**Subject: MHI's 2nd Amended Response to US-APWR DCD RAI No. 740-5719
Revision 2 (SRP 06.02.02)**

2nd Amended Response to Request for Additional Information
No. 740-5719 Revision 2

RAI NO.: NO. 740-5719 REVISION 2
SRP SECTION: 06.02.02 – Containment Heat Removal System
APPLICATION SECTION: 6.2
DATE OF RAI ISSUE: 4/26/2011

QUESTION NO.: 06.02.02-64

Figure b-1 Film Condensation at Structure Surface

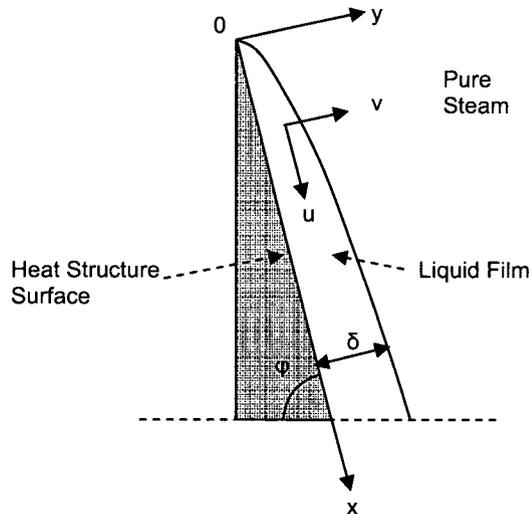
- o Condensate water on containment surfaces – Equation listed for film condensation correlation used to calculate film thickness could not be readily verified (reference in Japanese) and was not found in standard textbooks on heat and mass transfer. Appropriate reference and justification should be provided for the applied methodology and selected input values. Film thickness will be a function of the

surface height. Justify estimated vertical surface area and corresponding heights used in the calculations.

Condensate film thickness was calculated from Eq. 11 in the hold-up volume calculation based on the fluid conditions. The calculation follows the methodology of theoretically solving the Nusselt film heat transfer correlation, which is widely known (References 4 and 5).

Assume constant condensation and liquid flow on structure surfaces (Figure b-1).

$$\delta = \sqrt{2} \left\{ \frac{c_{pL}(\theta_S - \theta_W)}{L} \right\}^{\frac{1}{4}} \frac{1}{(Gr_x Pr_L)^{\frac{1}{4}}} x \quad (\text{Eq. 11})$$

Condensation liquid thickness on the surface of the heat structure is predicted by Eq. 11. The height used for this calculation was 40 meters (about 130 feet), and the resulting condensation film thickness (based on 40 meters height) was applied to all surfaces. The vertical portion of containment from the second floor level (EL 25'-3") is about 129 feet. If the vertical height (x) increases, the liquid film thickness also increases as shown in Eq. 11. However, the liquid thickness calculated based on a 40 meter height was conservatively applied to all surfaces.
